Project Title: Water Lane, Angmering

Project No/ Document Reference: A290-TN001

DRAINAGE – HOLDING OBJECTION

Further to your email, in response to our clients reserved matters and discharge of conditions application, please find below further information regarding your comments from Laura Gibbons, Engineer, on behalf of Adur & Worthing Councils. This response refers to Application Reference A/109/20/RES. We also refer you to the idom merebrook, Flood Risk Assessment, Ref: FRA-19495-16-139 Rev R2 approved at outline planning (A/99/17/OUT) and which we adhere to throughout.

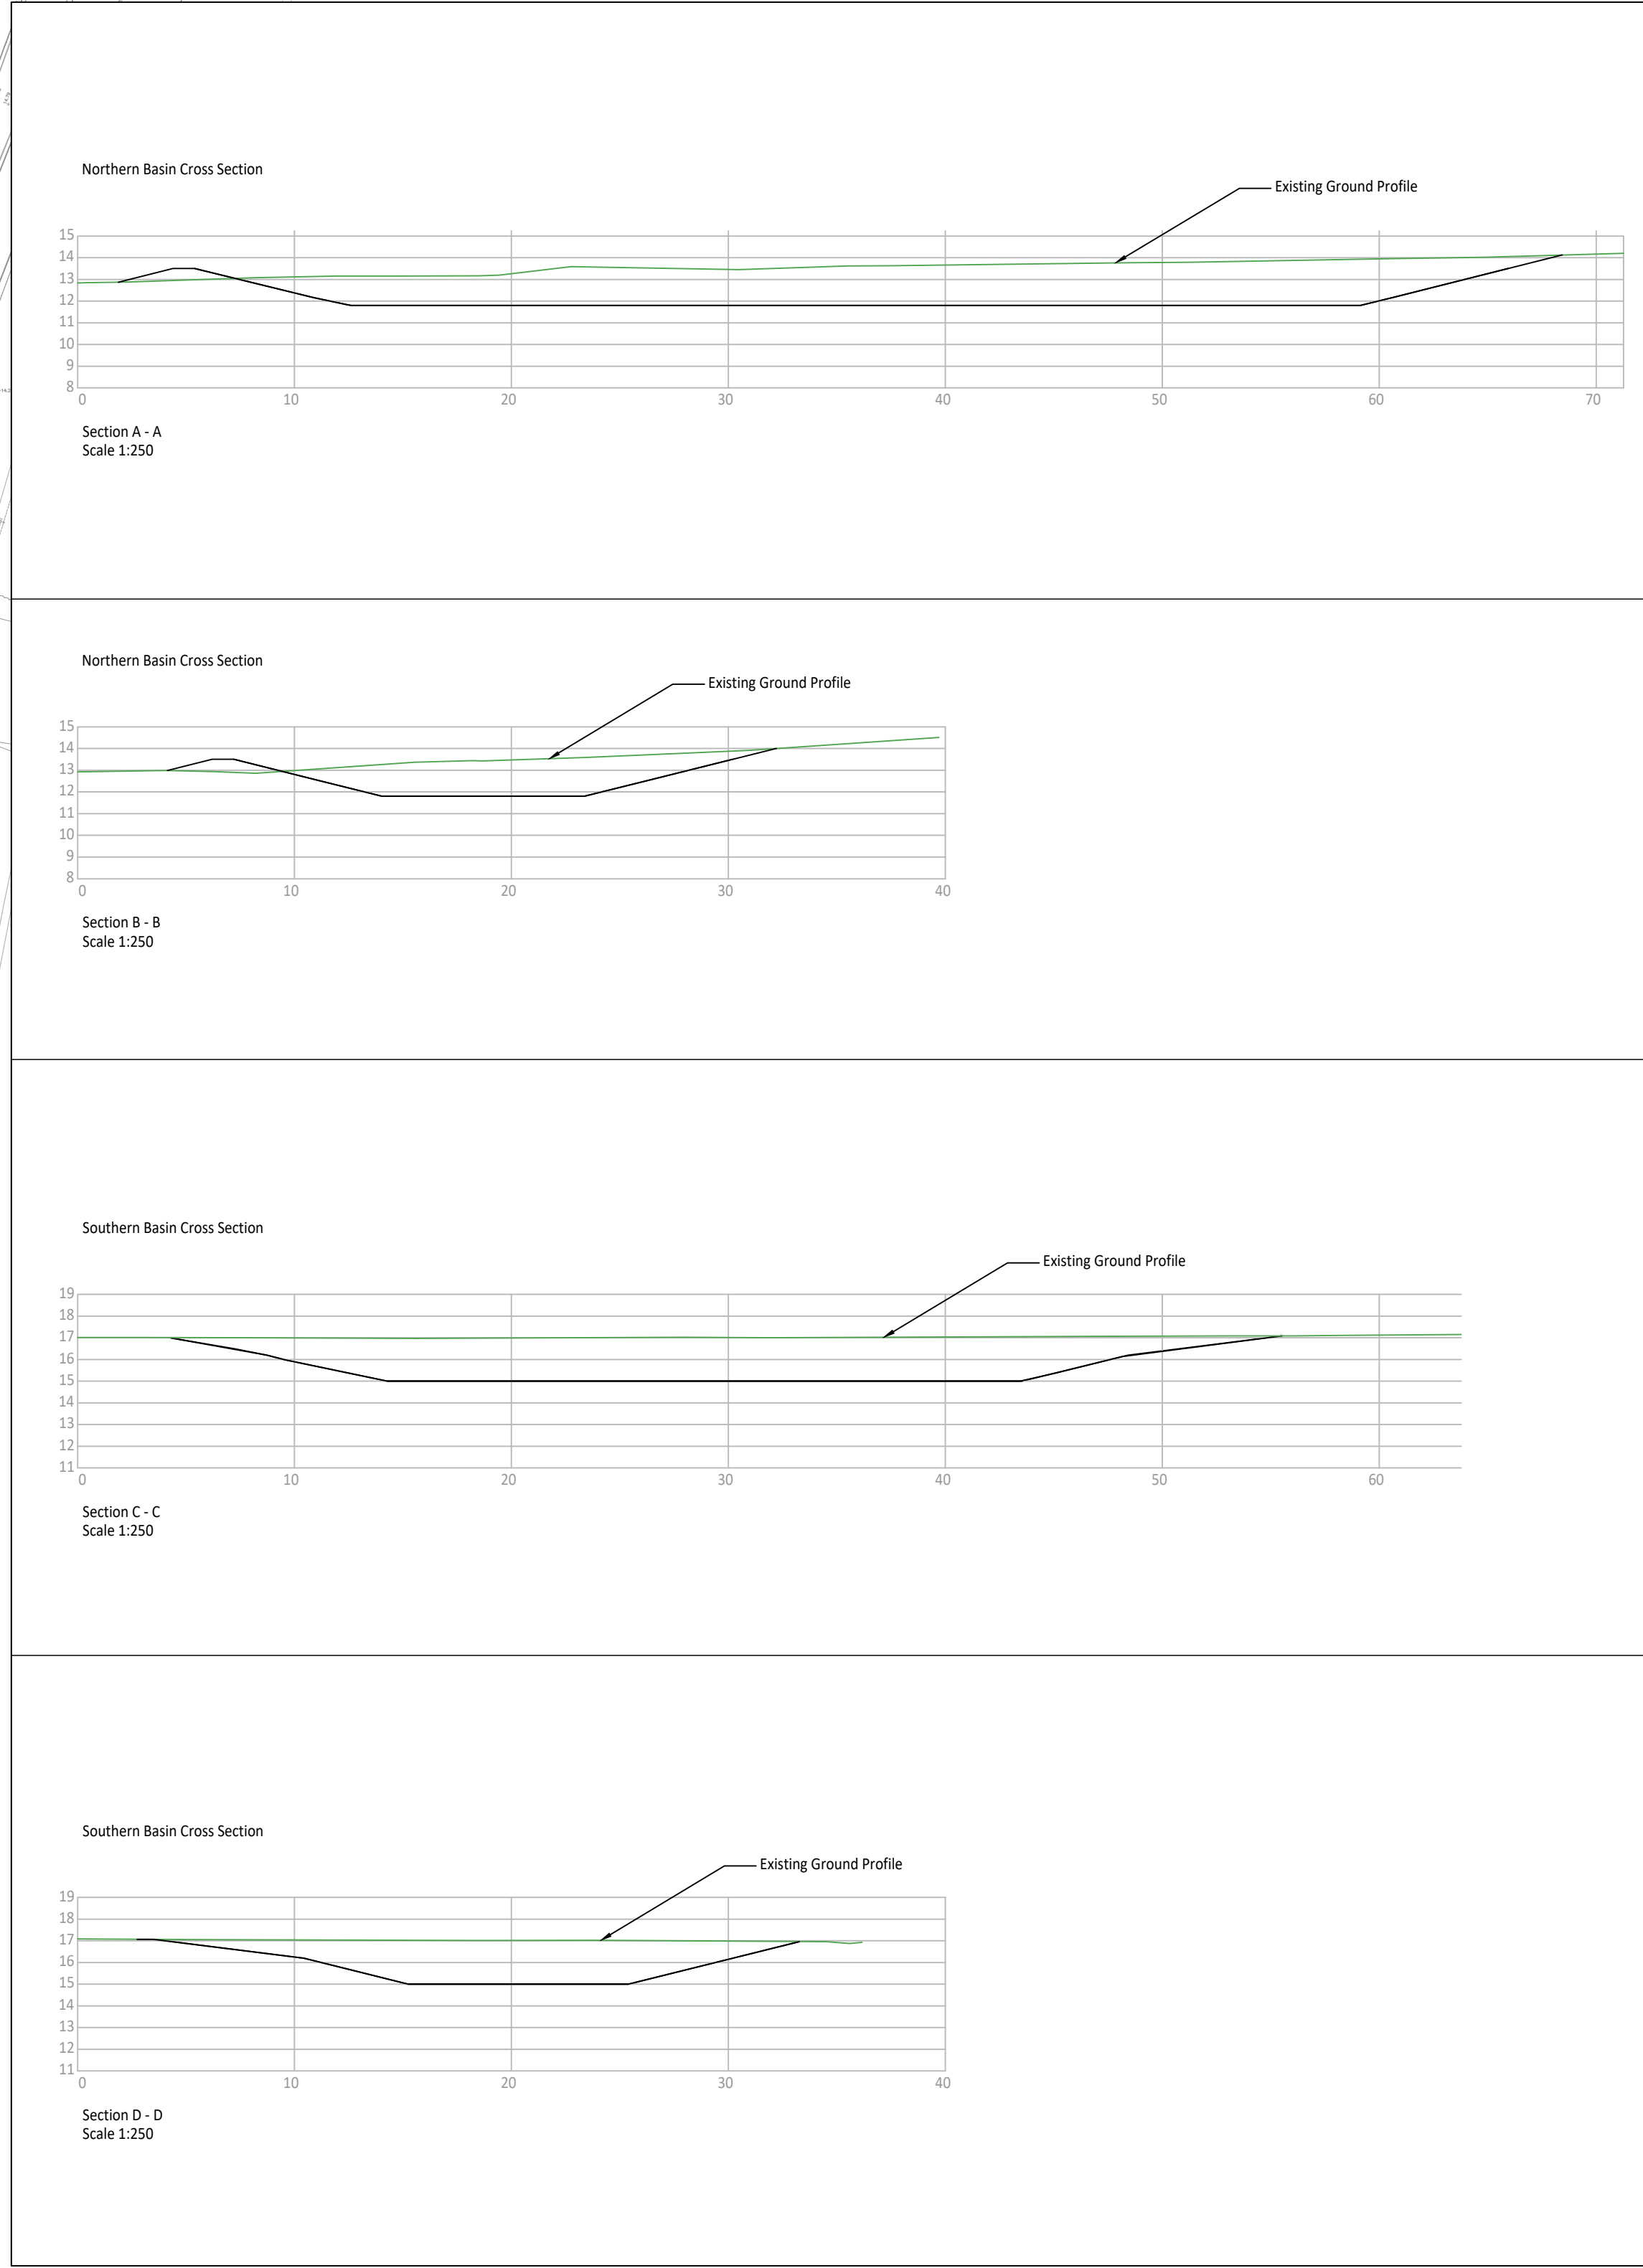
An impermeable areas plan, clearly identifying areas draining to each surface water drainage area is required. This should also be broken down further to areas draining to pipe numbers.

Two perpendicular cross sections per basin are required to verify modelled areas/ volumes.

We have included drawing A290-RM-512 P1, Post Development Catchment Areas and Basins, providing the impermeable area plan. Within the RM submission we included drawings A290-RM-501 P2 and 502 P2, Drainage Layouts Sheets 1 and 2, providing all proposed drainage levels and manhole numbers. In addition, within the submitted Drainage Statement (A290-R007) we included all Micro Drainage calculations including impermeable areas draining to each manhole. Therefore, all information has been previously submitted.

We have included drawing A290-RM-512 P1, Post Development Catchment Areas and Basins, providing cross sections of both Basin North and South
